US Custom House Museum and Carriage House

Town of Barnstable ADA Transition Plan

September 2021

Institute for Human Centered Design

Parking Lot

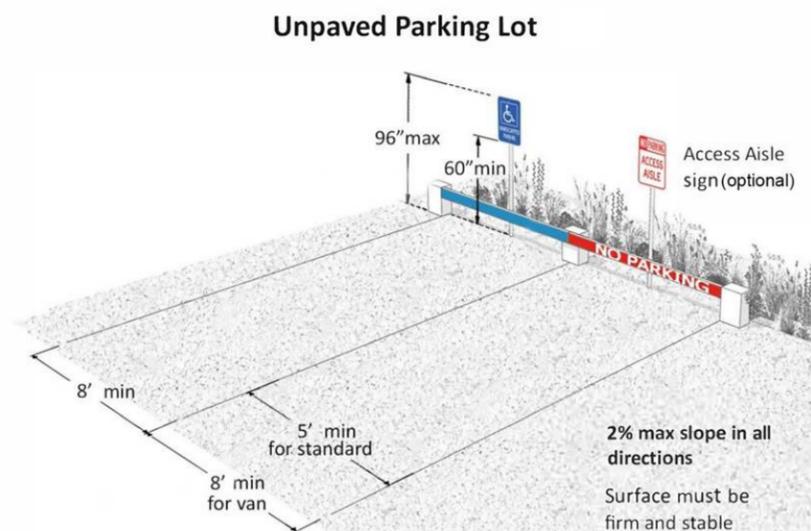
Accessibility issues include lack of an access aisle and the surface is not stable firm and slip resistant. (see sketch)
